# Access Compliance Report

## Public Rights-of-Way

### (Pedestrian Signals)

Intersection ID: N/A	Main Street:	Cross Street: N/A	Location: N/A
ADA ID: D5F846CE5E9F	Signal Type: One Push Button-Non APS	Overall Compliance: No	Severity Score: BTN 1: N/A BTN 2: N/A No BTN: N/A
Codes/Mitigation Info/Possible Solution		Field Measurements/Component Compliance

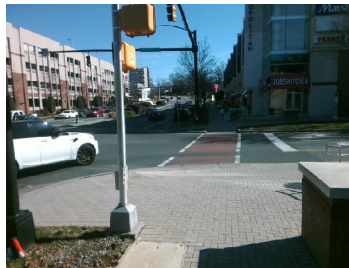
PROW/ADA: TMUTCD 4e.08, R404.2, R404.3, R406.2

Possible Solutions: Replace Signal Push Button With APS Button on New Post. Remove & Relocate Sign.
